SERVICE BULLETIN

Service Bulletin No.: DA20-27-01, Rev. 0

Title: Flap Actuator

Figure 1. Current Limiter Mounting

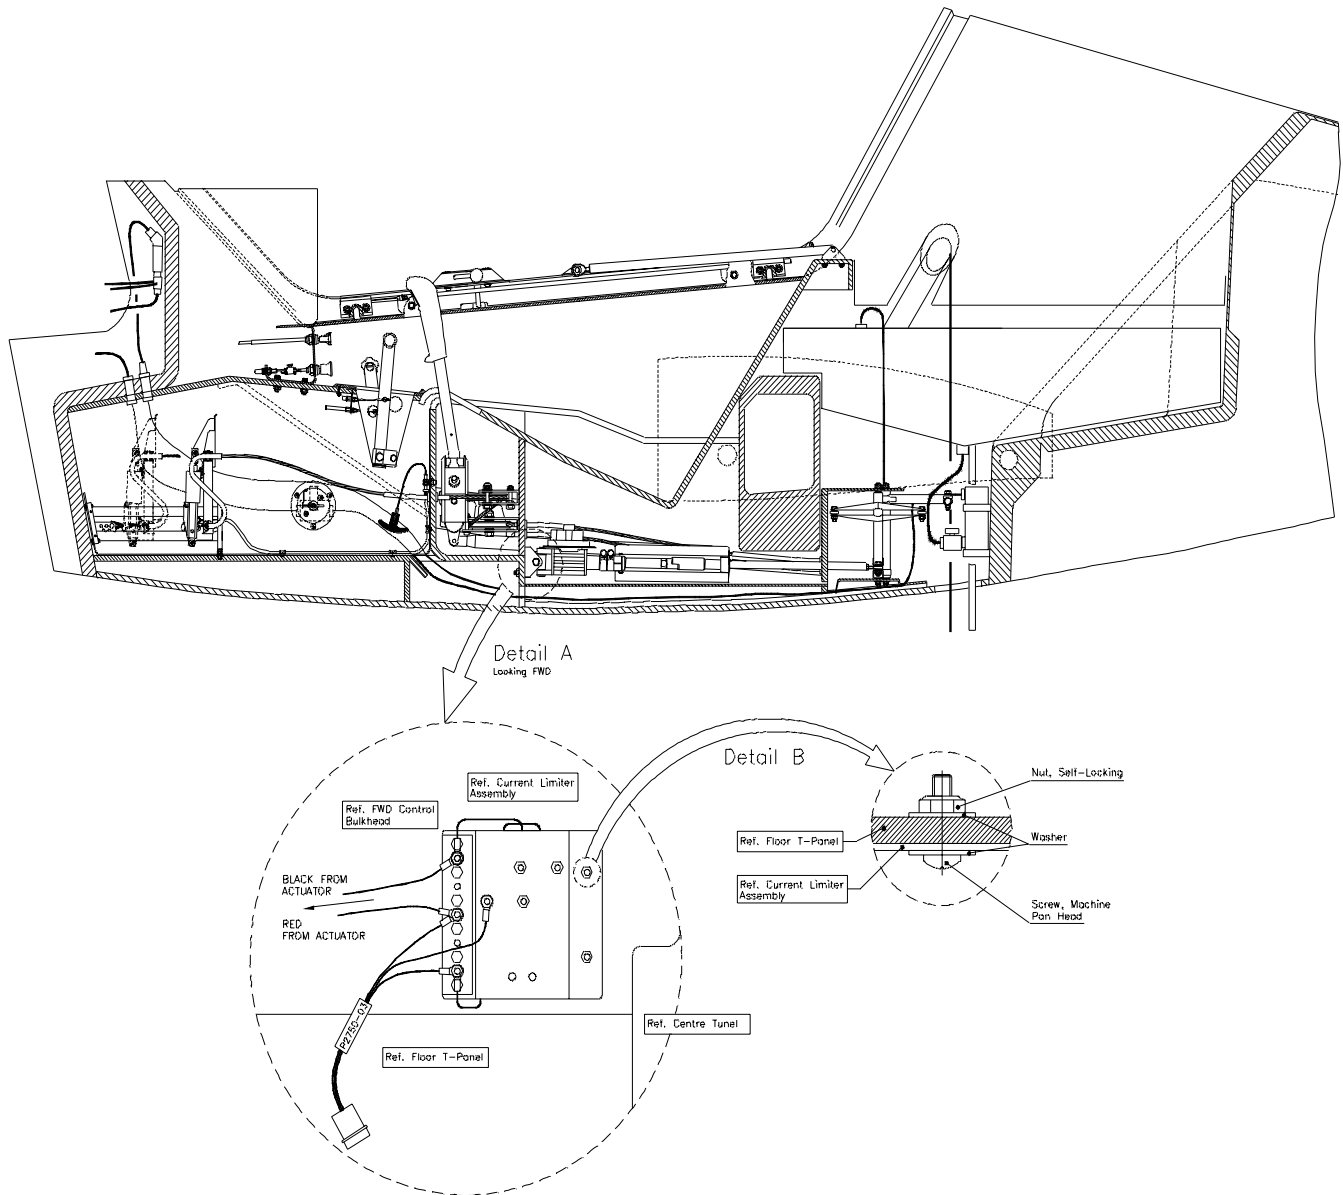
- 11.5 Re-install AN4-16A bolt to secure actuator.
- 11.6 Drill 0.125" diameter holes for the current limiter in the forward control bulkhead, locating them in accordance with Figure 1.

- 11.7 Secure current limiter with hardware supplied as per Figure 1.
- 11.8 Connect motor wires and current limiter wires in accordance with Figure 2 and fasten loose wires with tie-wraps.

Figure 3. Flap Limit Switch Tray

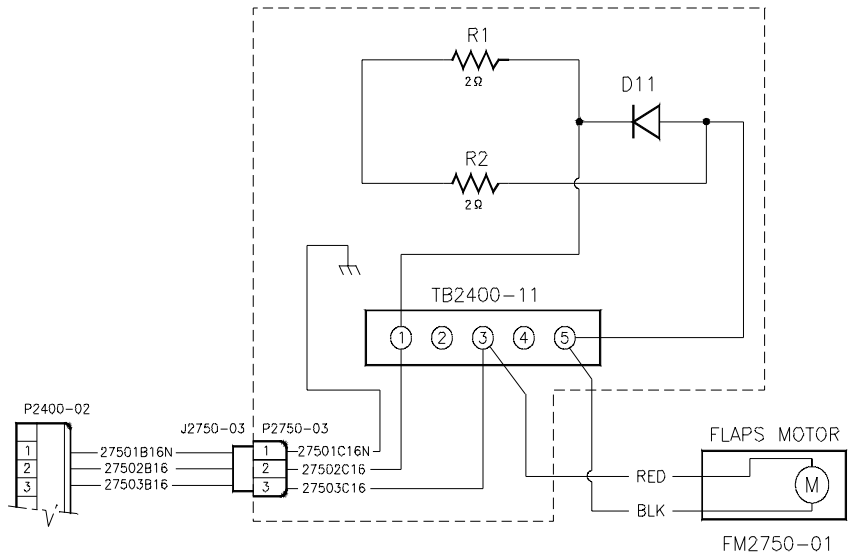
- 11.10.10 Retract flaps to cruise position and check flap pre-load.
 - 11.10.11 If pre-load is above limits, loosen gear clamps on flap limit switch tray and move tray slightly forward. If preload is below limits move tray slightly aft, refer to Fig. 3.
 - 11.10.12 Recheck flap readings.
 - 11.10.13 If any readings are out of limits, adjustments can be made by moving the appropriate individual limit switch (Figure 3).
- 11.11 Cycle flaps and check current limiter voltage in accordance with Maintenance Manual Sub-Chapter 27-50.
- 11.12 With flaps in cruise (UP) position, readjust flap up-stop so that washers can still be rotated by hand.
